Our file - Notre référence
NWB3CAP0207

Re: Cape Dorset Lagoon/ Sewage Spill Follow up, May 5, 2004

Figure 1. The berm in the first cell of the new Sewage Lagoon in Cape Dorset.

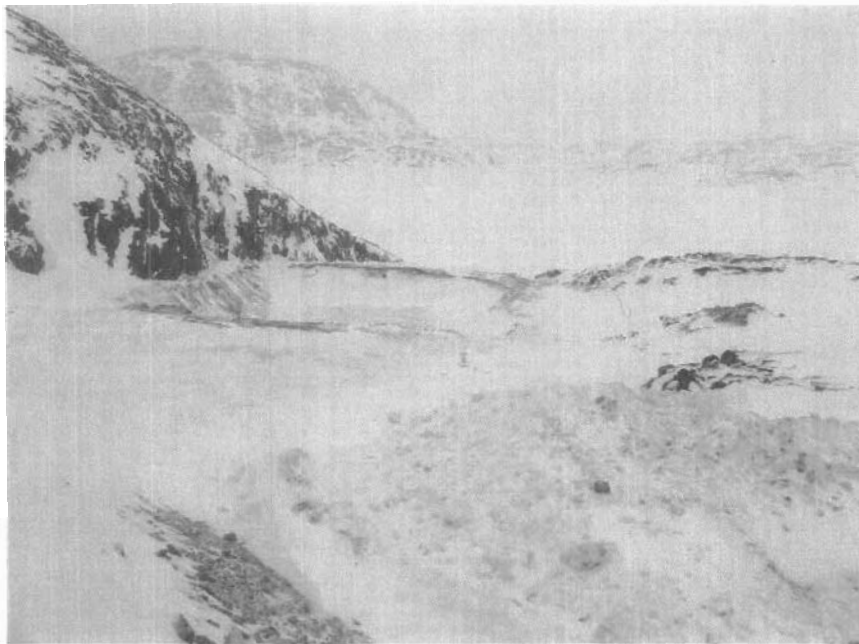
that the 3-celled lagoon is in imminent danger of overflowing and washing out as soon as the spring melt begins. The first cell is close to the level of the overflow culvert (Figure 1) while the second cell is full above the overflow culvert and has surpassed the surface of the berm in one area (Figure 2 and Figure 3). The sewage that has overflowed from cell one is flowing along the diversion channel on the mountain side of cell two. This overflow from cell one has produced a large build up of ice that is moving down the side of cell two (Figure 4). It appears that this sewage shall both erode the side of cell two and possibly flow along the mountain side, by-passing the third cell entirely. The situation could potentially result in a catastrophic failure of cells two and three of the lagoon.

Figure 5. The original Sewage Lagoon in Cape Dorset with the truck discharge point visible in the foreground.

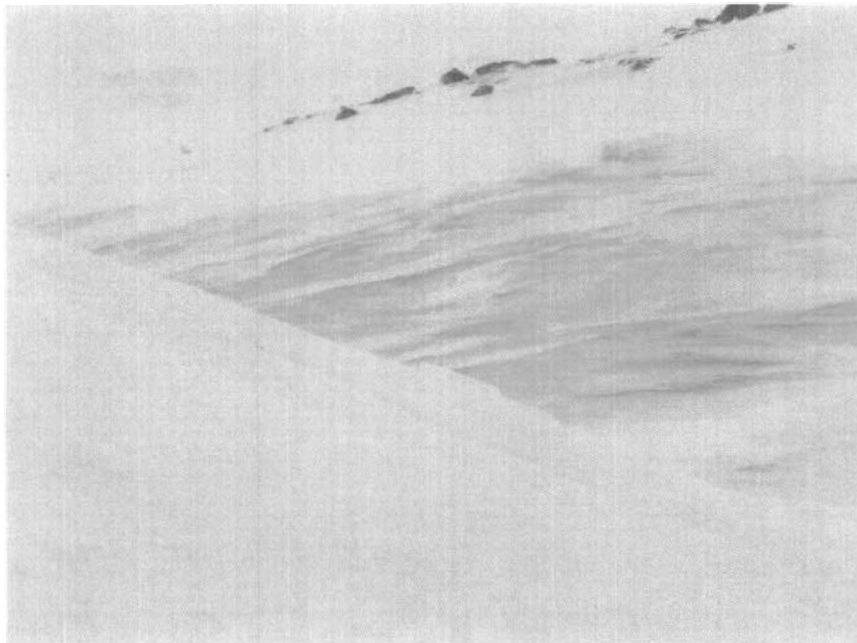
The original lagoon (Figure 5), which has been brought back into service does not have sufficient capacity to treat the communities sewage and the lagoon discharges continuously with minimal retention time. Additional retention berms put in place last summer to increase the retention time of the lagoon have been ineffective (Figure 6). The sewage effluent has surpassed the level of the additional berms and it flows virtually unimpeded into Telik Inlet. Consequently, there is a deposit of minimally treated sewage effluent visible on the ice in Telik Inlet.
